**Sur-Rebuttal Analysis  
of the Applicant's  
Experts' Rebuttal Opinions**

By  
Dr. Willem A. Schreüder & Dr. Devraj Sharma  
Principia Mathematica Inc.

June 19, 2000

Case No. 96CW014: Application for Water Rights by Park County Sportsmen’s Ranch, LLP

Figure SR-4a.

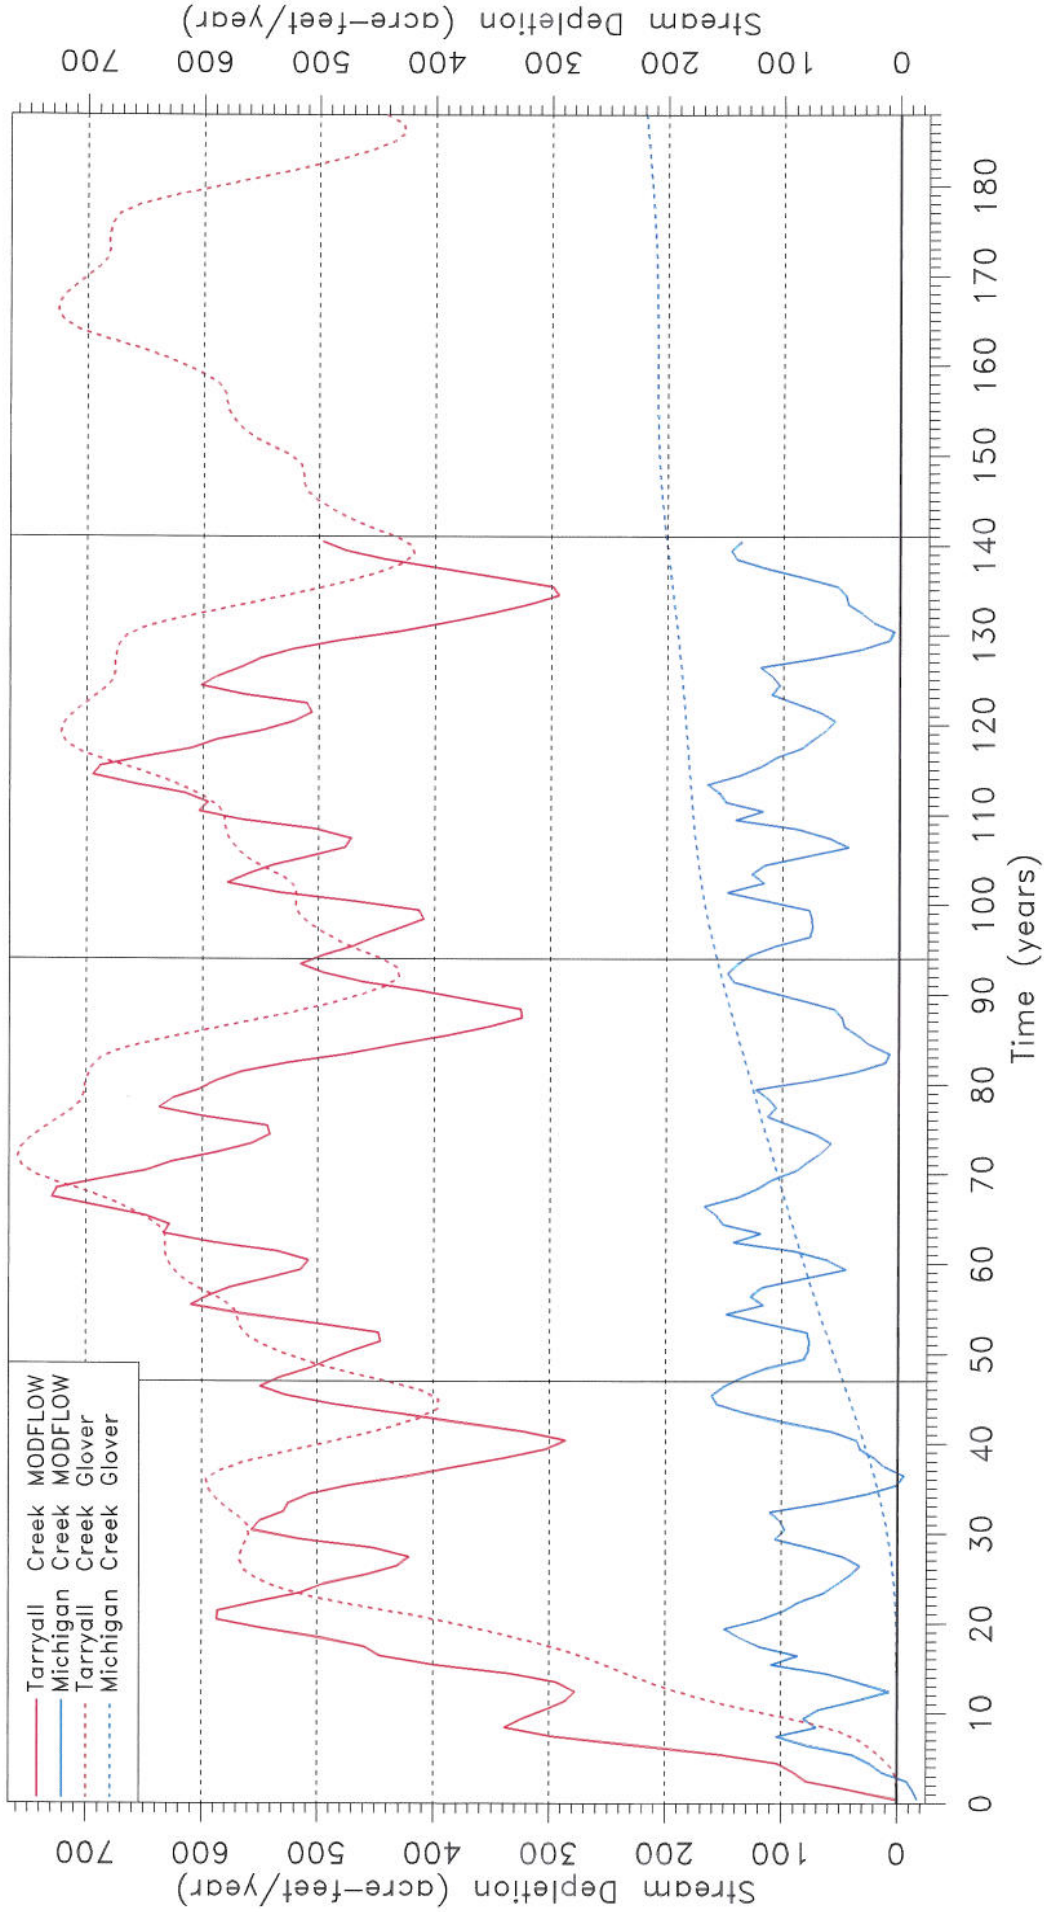
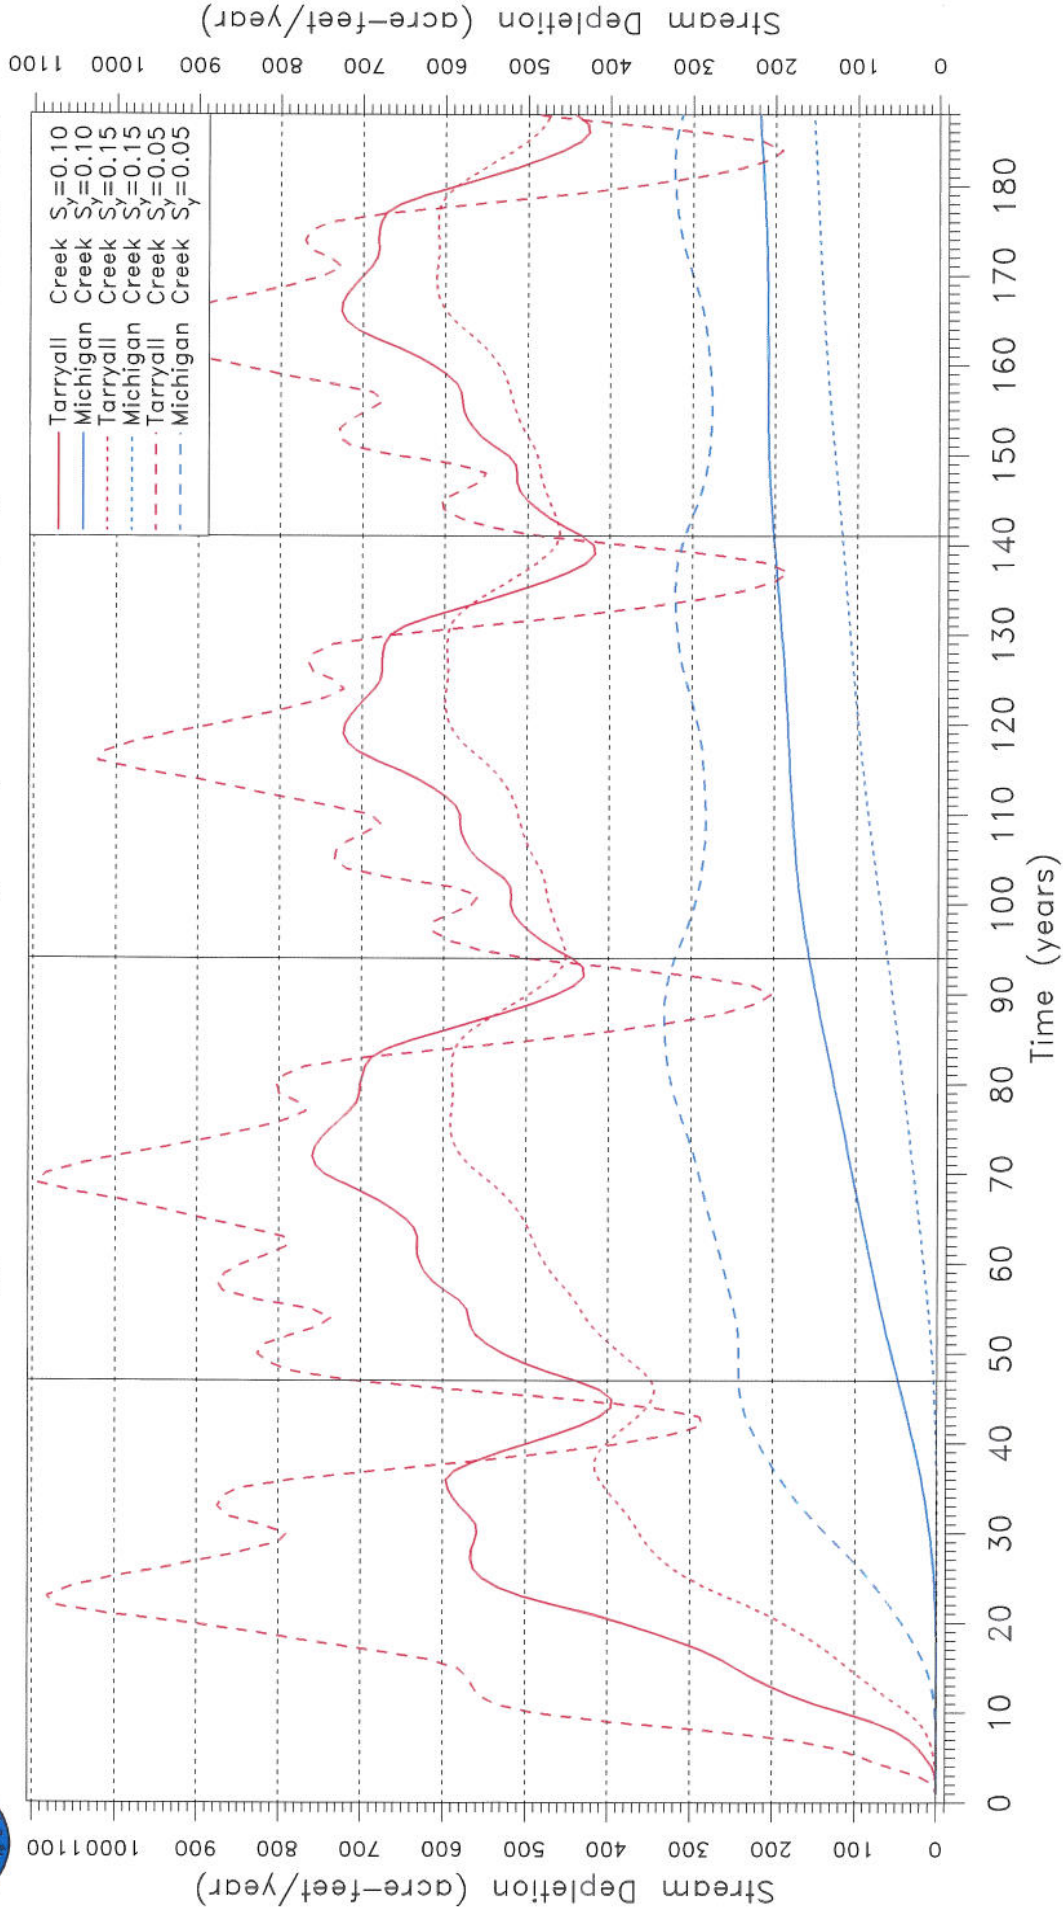
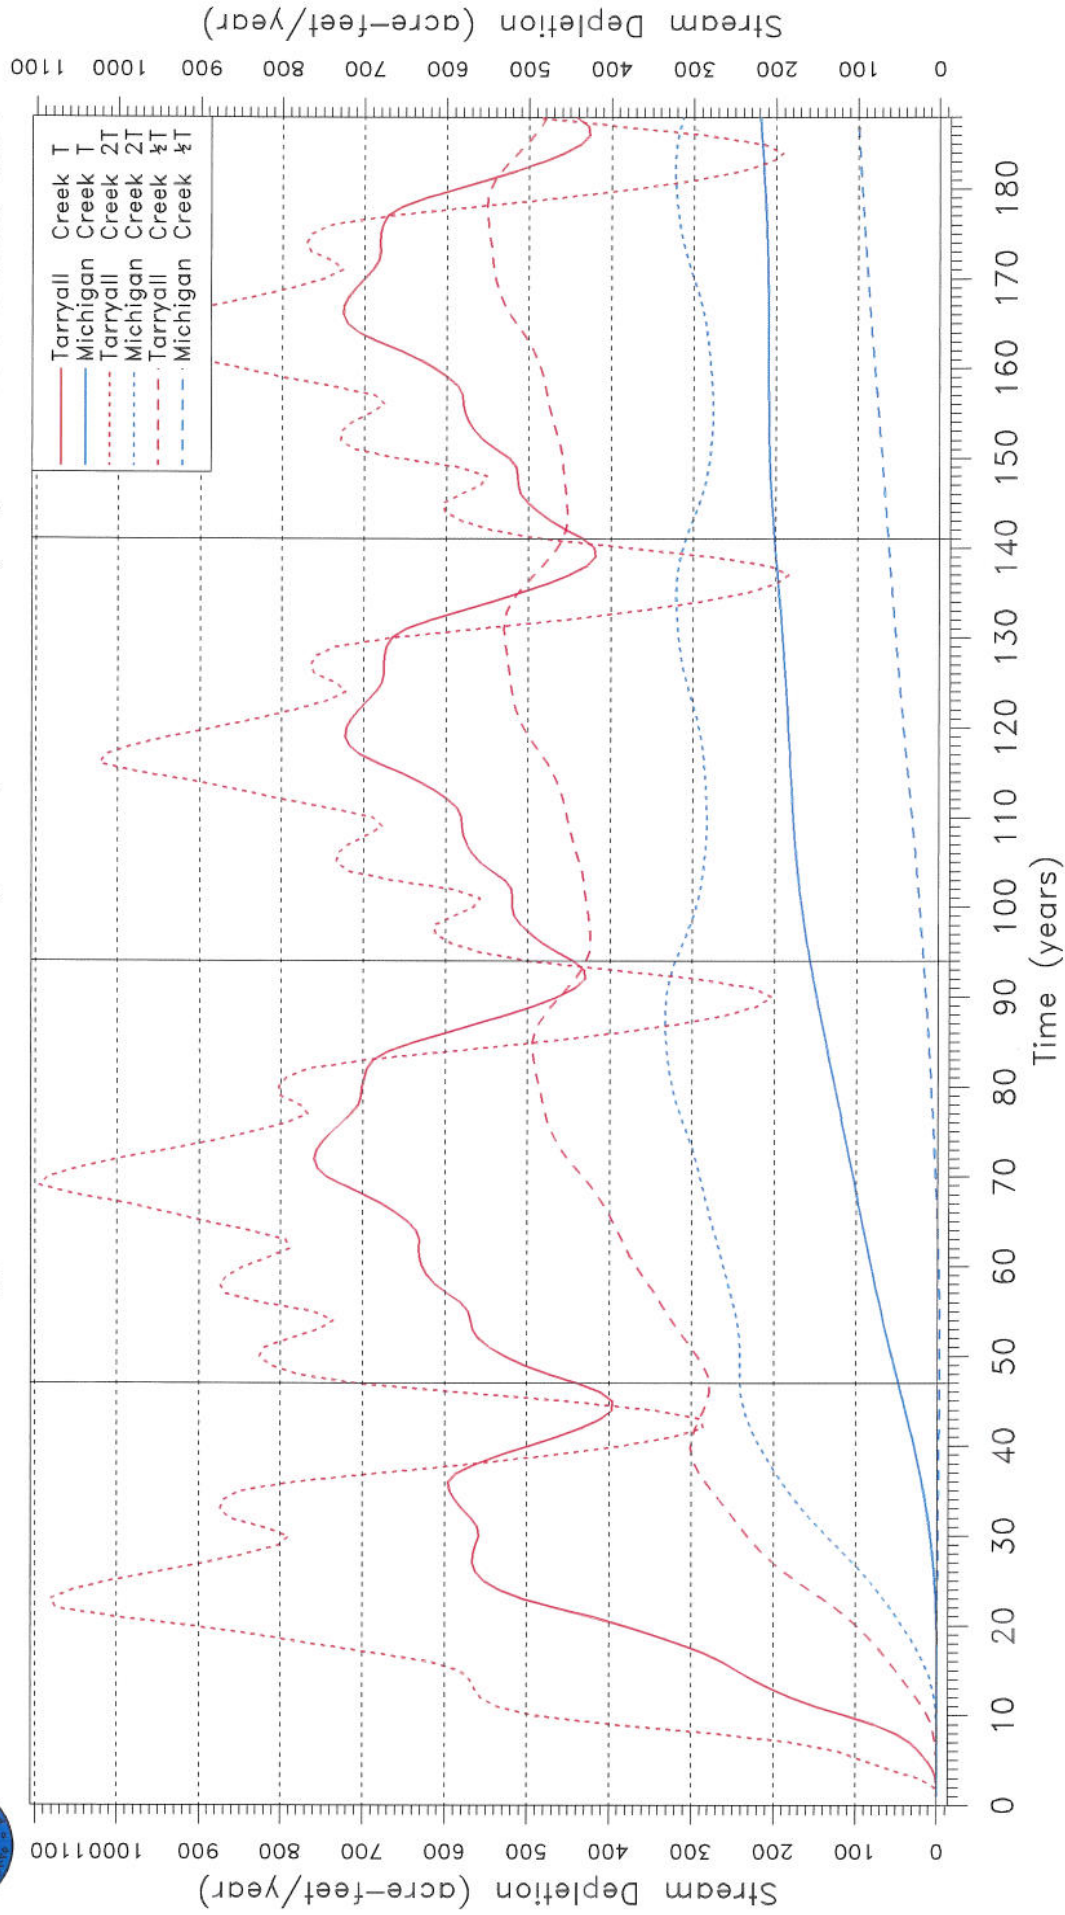
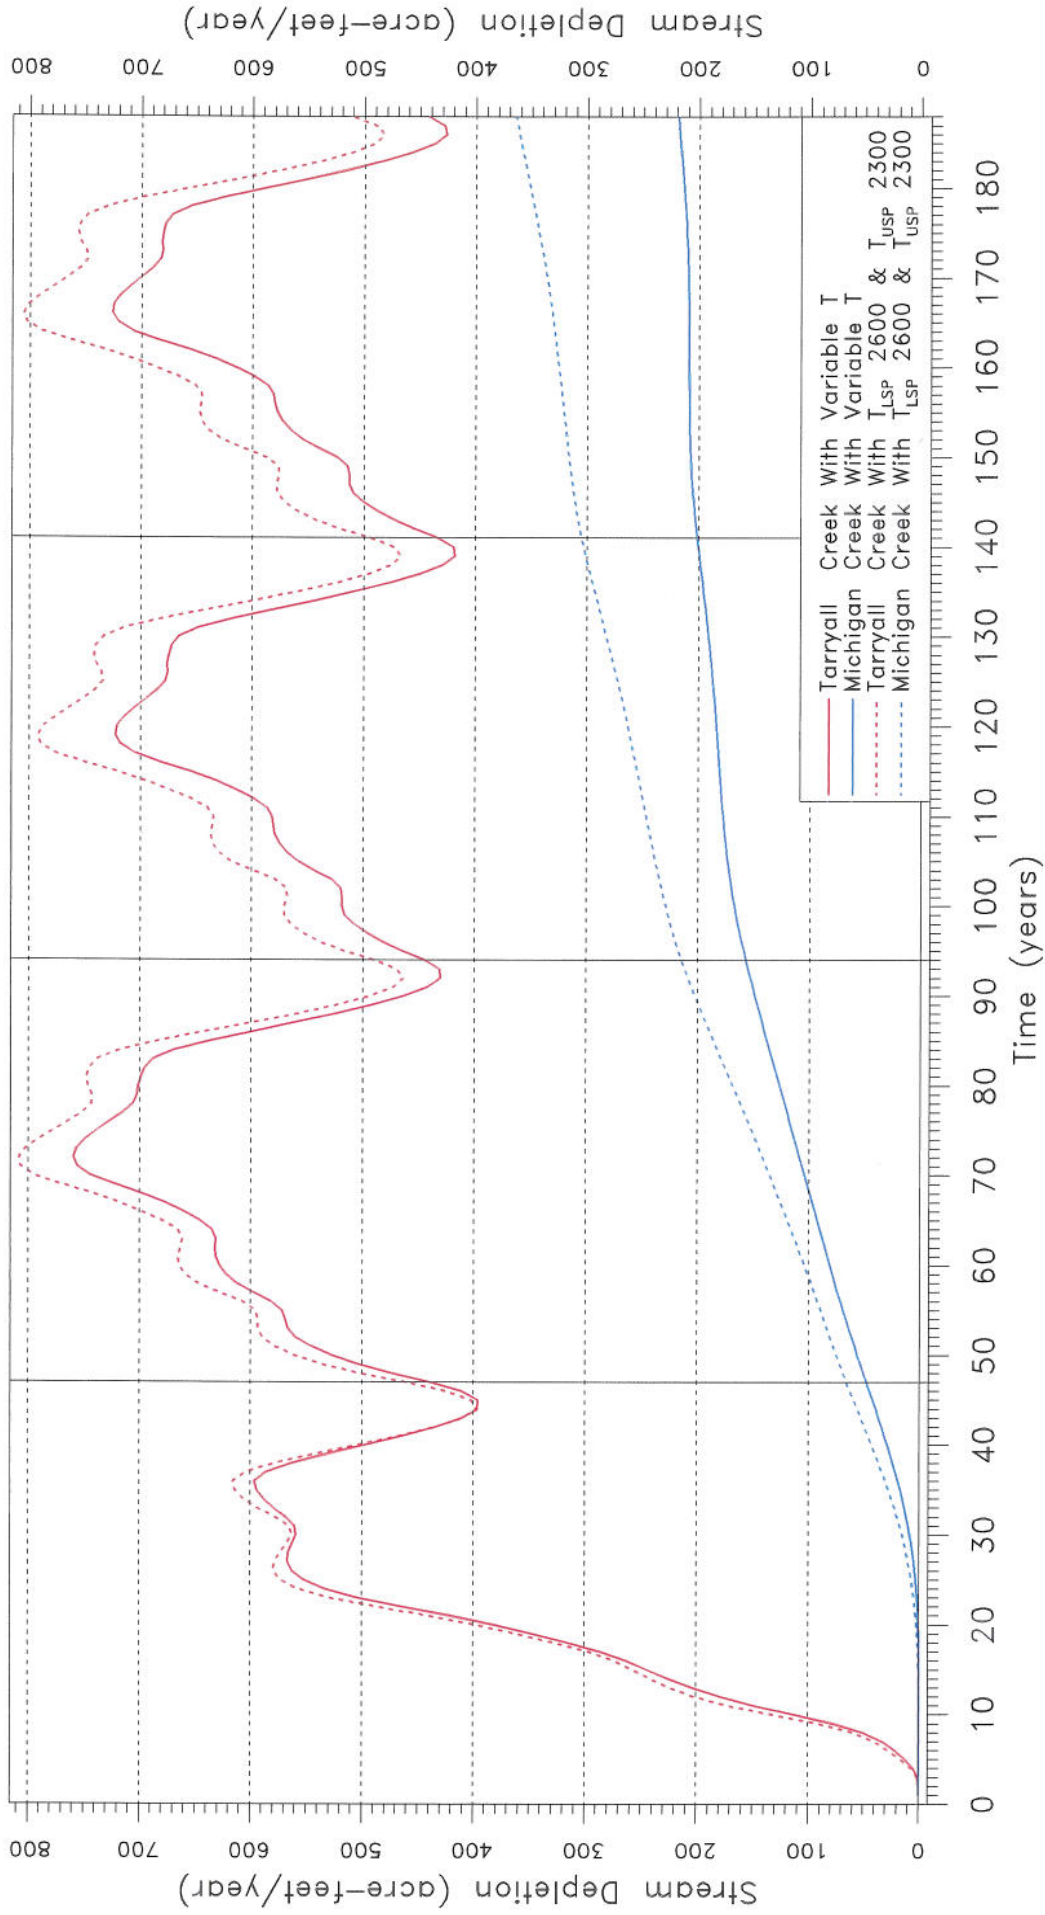
- (22) To counter the numerous criticisms of the Applicant's model made by Objectors' experts and documented in their reports, the Applicant's rebuttal experts at RMC have recently attempted to corroborate the claimed reasonableness of stream depletions predicted by their ground water model. They have done so by modifying the computer program for Glover-Method analysis developed by the Colorado State Engineer's Office and creating an analytical model of the upper Tarryall Creek basin. Principia has evaluated this approach and concluded that

the simplistic analytical solution known as the "Glover Method" does not and cannot properly represent the complexities of the South Park ground water system. This is due to the large number of simplifying assumptions made in order to derive the analytical solution and the fact the South Park ground water system cannot be represented with such assumptions. In fact, this was the very reason that the Applicant's experts spent over two years trying to build a numerical model of the system using the **MODFLOW** computer program. Now, in rebuttal, the Applicant's experts claim that the Applicant's numerical ground water model predictions are reasonable and in line with its Glover Method analysis. Principia's sur-rebuttal analysis indicates that wherever results predicted with this method appeared to be somewhat similar to those of the Applicant's ground water model, it was because the identical property values were assigned to the two procedures. Since they both seek to represent ground water flows, it is not surprising to Principia that this result was achieved. However, when Principia evaluated the large number of assumptions embedded in the Glover Method [*see Glover, 1974*], and ran sensitivity tests of property values utilized with it, a significantly different picture emerged. This picture is depicted in Figure SR-4a through Figure SR-4d. The depletions to Tarryall and Michigan Creeks predicted by the Applicant's ground water model and its application of the Glover Method are illustrated in Figure SR-4a. The significant differences between the two procedures even for the identical property assignments may be clearly observed. The sensitivity of stream depletions predicted by the Glover Method to prescriptions of specific yield are illustrated in Figure SR-4b, for the same two streams. Likewise, the sensitivity of the Glover Method to prescribed transmissivity values is illustrated in Figure SR-4c. In calculating the aquifer transmissivity for use in this analysis, the Applicant's expert used the well's screen interval in the aquifer to calculate a different transmissivity value for each well. This is clearly incorrect and runs counter to the Glover Method assumptions. If a constant aquifer average transmissivity value is used for each well, the predicted depletions will be greater as illustrated in Figure SR-4d. It will be apparent by now, and not surprisingly, that the magnitude of stream depletions predicted by the Glover Method depart very significantly from those predicted by the Applicant's ground water model. Hence, the Applicant's experts' rebuttal opinions regarding this matter are entirely without merit.
